Amendment No. 55
License No. DPR-20

ATTACHMENT TO LICENSE AMENDMENT NO. 55
PROVISIONAL OPERATING LICENSE NO. DPR-20
DOCKET NO. 50-255

SAFETY EVALUATION BY THE OFFICE OF NUCLEAR REACTOR REGULATION
SUPPORTING AMENDMENT NO. 55 TO PROVISIONAL OPERATING LICENSE NO. DPR-20

PALISADES PLANT

PRESSURE-TEMPERATURE LIMITS
INSERVICE TEST-TO 5.5 X 10⁶ MWDT
FIGURE 3-3

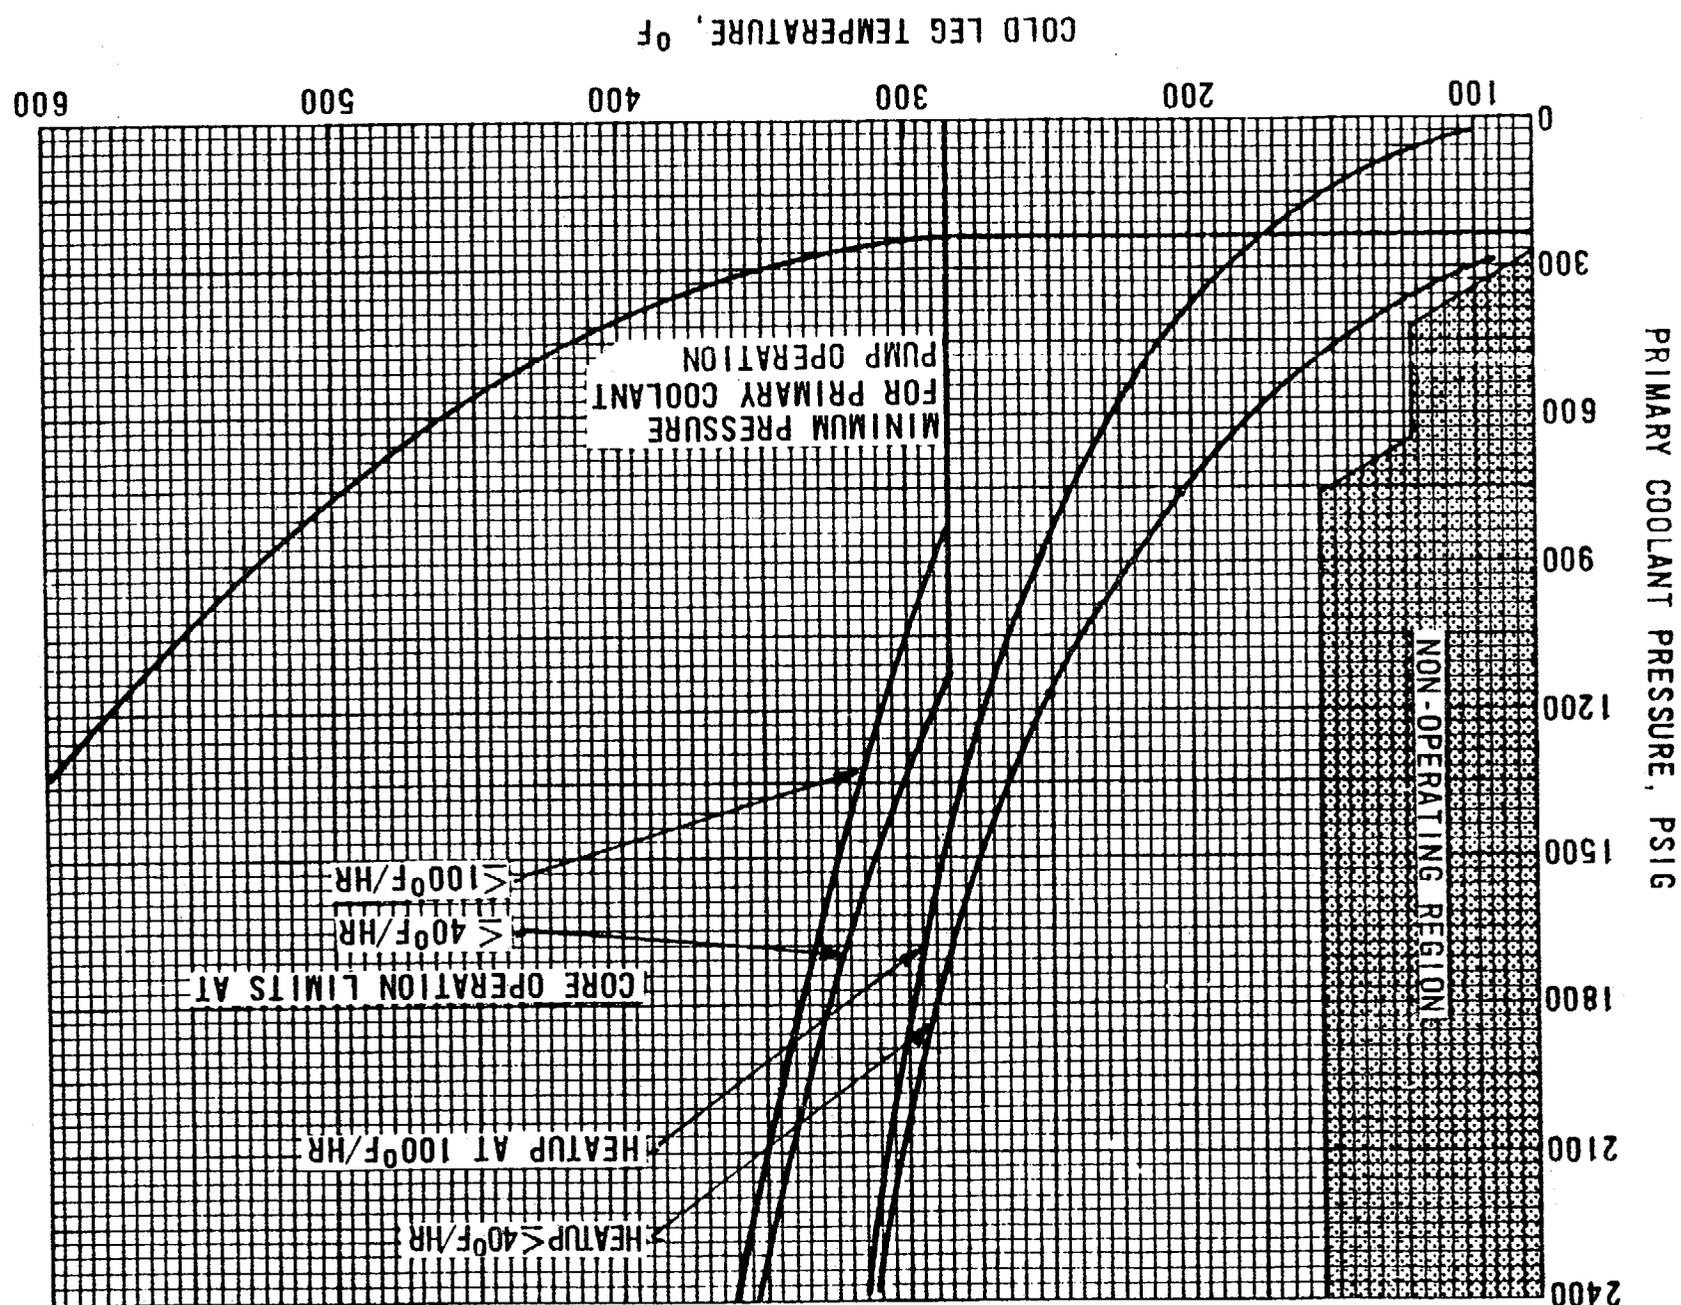
- c) Allowable combinations of pressure and temperature for inservice testing from heatup are as shown in Figure 3-3. Those curves include allowances for the temperature change rates noted above. Interpolation between limit lines for other than the noted temperature change rates is permitted in 3.1.2a, b or c.

PRESSURE-TEMPERATURE LIMITS
FOR HEATUP-TO 5.5 X 10⁶ MWDT
FIGURE 3-1

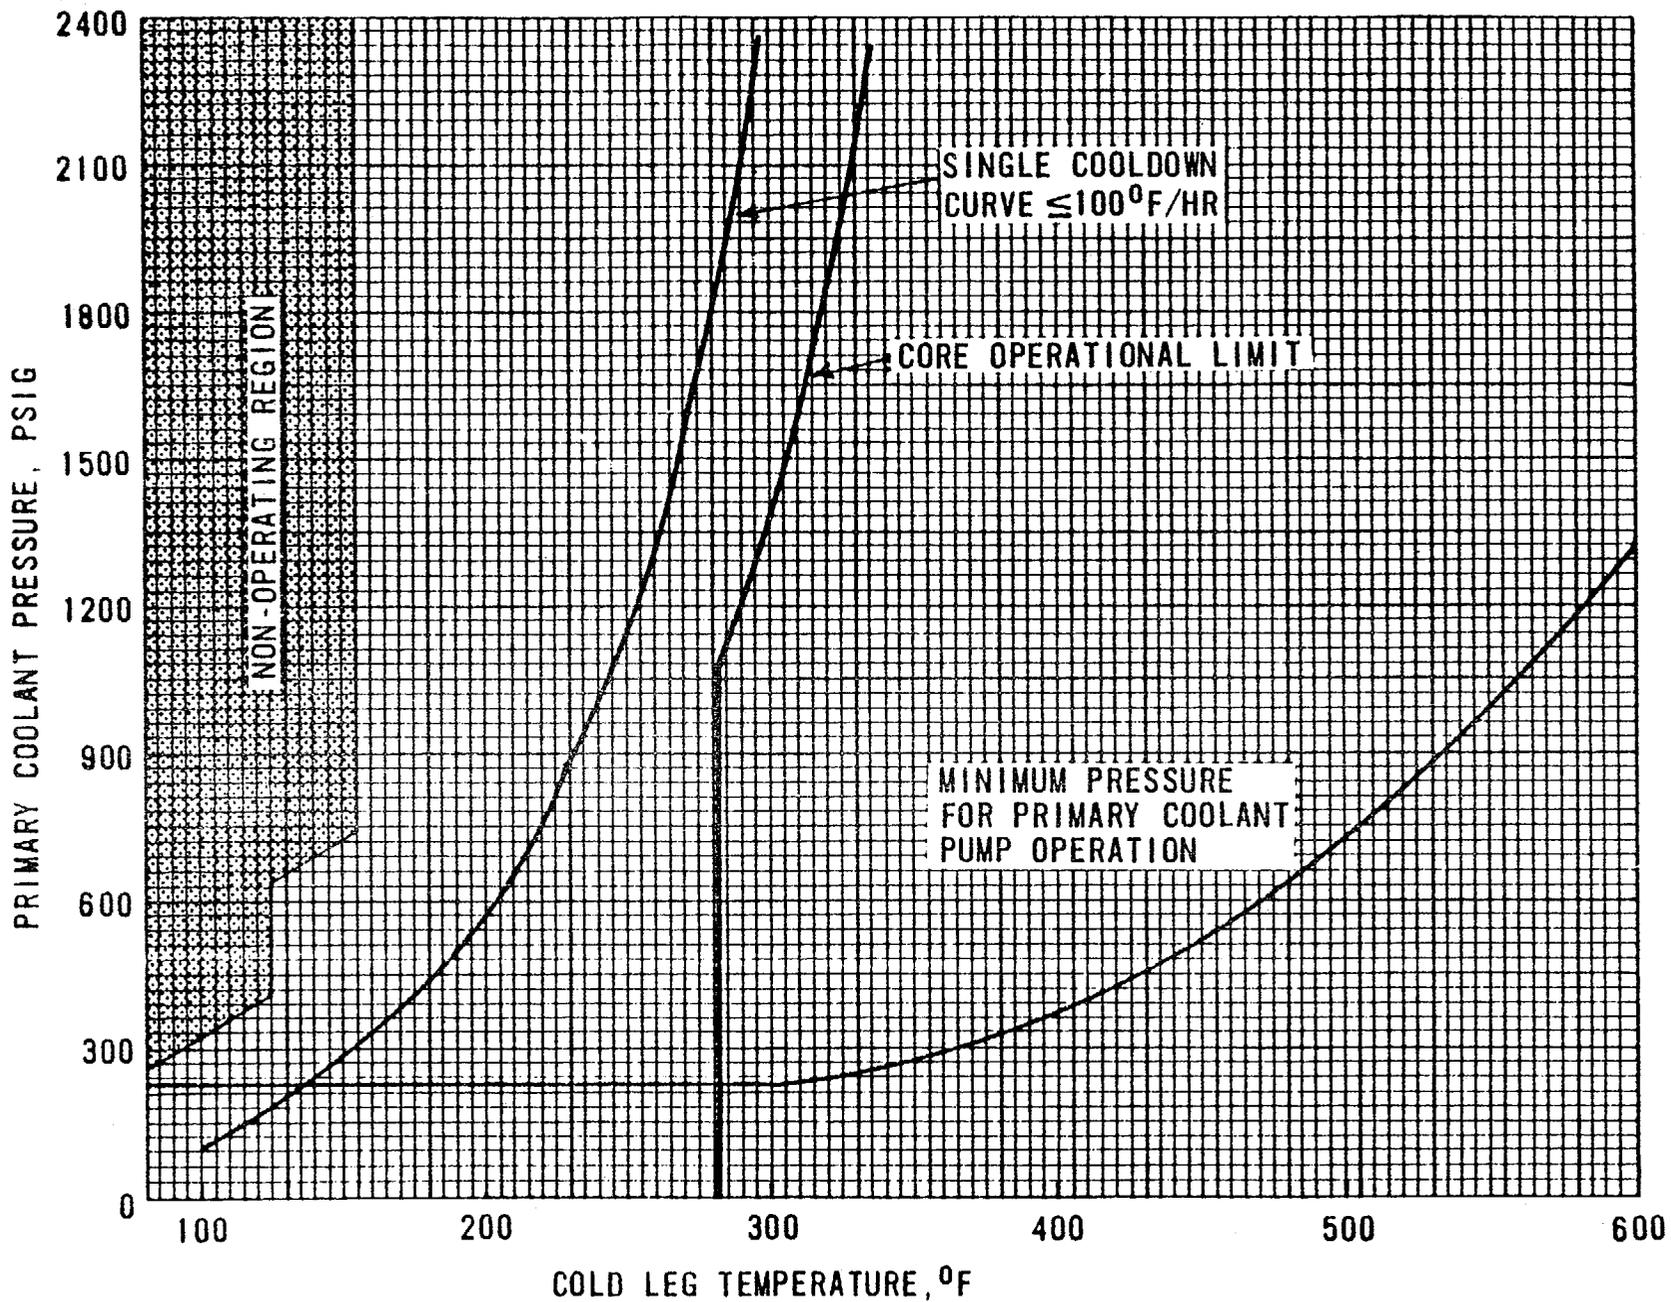
- a) Allowable combinations of pressure and temperature for any heatup rate shall be below and to the right of the limit lines as shown on Figure 3-1. The average heatup rate shall not exceed 100°F/h in any one-hour time period.

The revised pressure-temperature limits are applicable to reactor vessel inner wall fluences of up to 6.75×10^{18} nvt or approximately 5.5×10^6 MWd of thermal reactor power. The application of appropriate fluence attenuation factors at the 1/4 and 3/4 thickness locations results in fluences of 3.8×10^{18} nvt and $.95 \times 10^{18}$ nvt, respectively. From Reference 6, these fluences are extrapolated to RT_{NDT} shifts of 150°F and 75°F, respectively, for the limiting weld

PRESSURE-TEMPERATURE LIMITS
FOR COOLDOWN-TO 5.5 X 10⁶ MWDT
FIGURE 3-2

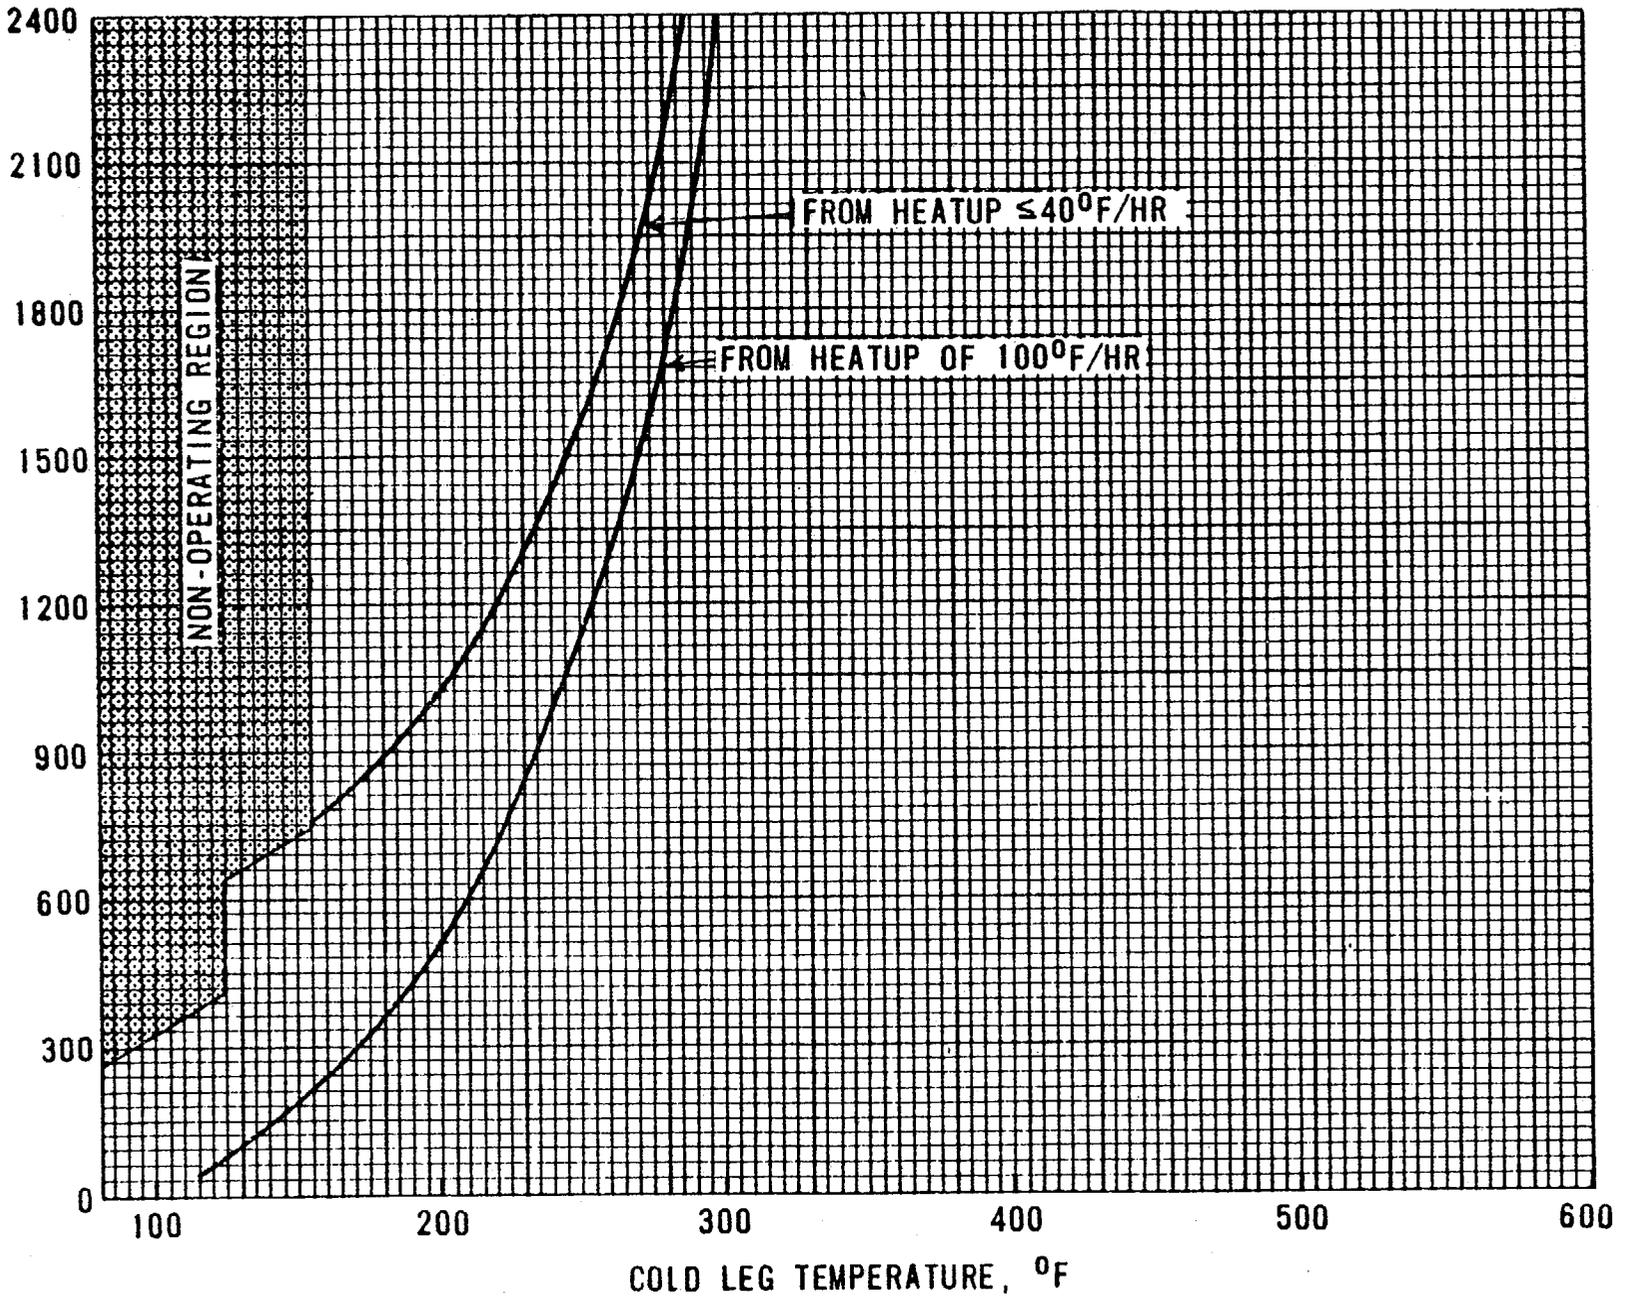
- b) Allowable combinations of pressure and temperature for any cooldown rate shall be below and to the right of the limit lines as shown on Figure 3-2. The average cooldown rate shall not exceed 100°F/h in any one-hour time period.
